2. Safety Issues Raised in this Stage 1 Road Safety Audit. (see Appendix B for locations)

Report title:	Designer's response to Stage 1 Road Safety Audit, Land at Woodgate Nurseries, Lidsey Road, Woodgate
Date:	24 th June 2024
Document reference and revision:	2401/RSA/DR/01
Prepared by:	Highgate Transportation Ltd
On behalf of:	Hanbury Properties

An Independent Stage 1 Road Safety Audit (ref: 240602) was undertaken by Avon Traffic & Safety Servies Ltd on 13th June 2024 with regard to the proposals to create a new pedestrian and cycle access from the A29 to serve up to 130 residential dwellings. The Road Safety Audit also reviews amendments to an approved bellmouth junction and new junction with a ghost island right turn lane on the A29 Lidsey Road which will also serve the 130 proposed dwellings.

Looking south on western footpath towards cycle crossing and development access

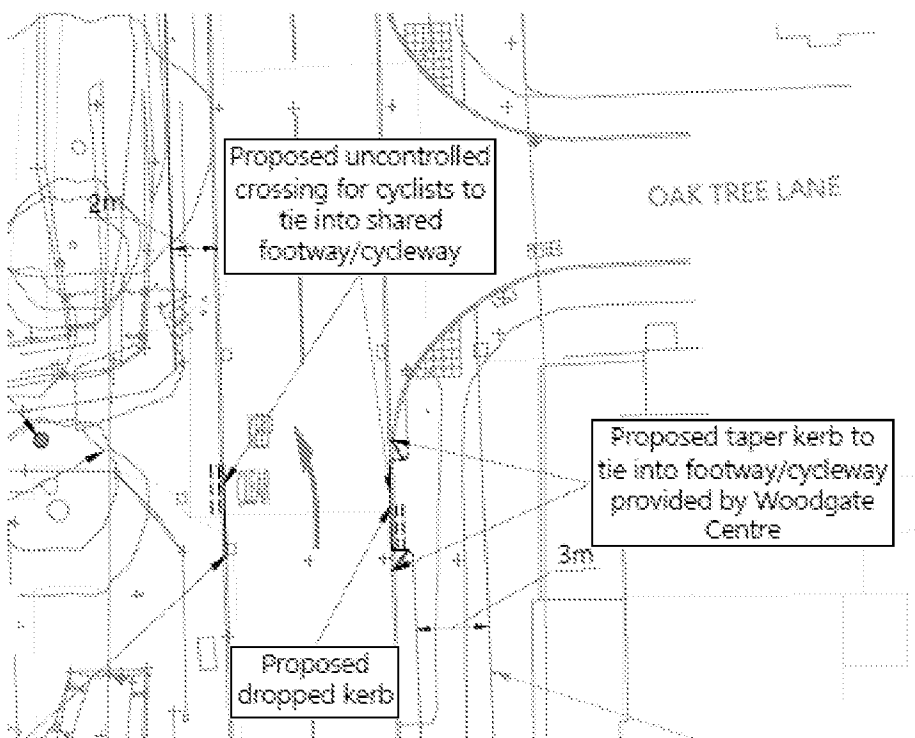
Location – Proposed footway/cycleway link, western footway

Summary – Risk of cyclist collisions with pedestrians due to inadequate warning

Lidsey Road is subject to a 30 mph speed limit and accommodates footways along both sides of the carriageway. The proposals provide for an approximate 3 metre shared footway cycleway link from the development to meet the existing western footway alongside Lidsey Road. However, no measures are provided to highlight the transition between the existing footways and proposed shared facility where cyclists are likely to be observed. As such, pedestrians, particularly the visually impaired, could step into the path of a cyclist, or a cyclist could continue on the footway, raising the risk of a cyclist/pedestrian collision.

Recommendation – It is recommended that sufficient warning is provided to highlight the change of use via appropriate corduroy paving and signing.

2.4 Location – Proposed footway/cycleway link, western footway Summary – Risk of cyclist collisions with pedestrians due to inadequate warning	It is recommended that sufficient warning is provided to highlight the change of use via appropriate corduroy paving and signing.	Agreed – Corduroy paving will be provided to show the transition between the footway along A29, and the shared used footway cycleway entering the site. The corduroy paving is shown on drawing HTP/2401/04/C Further detail will be provided at the detailed design stage.		
--	--	---	--	--
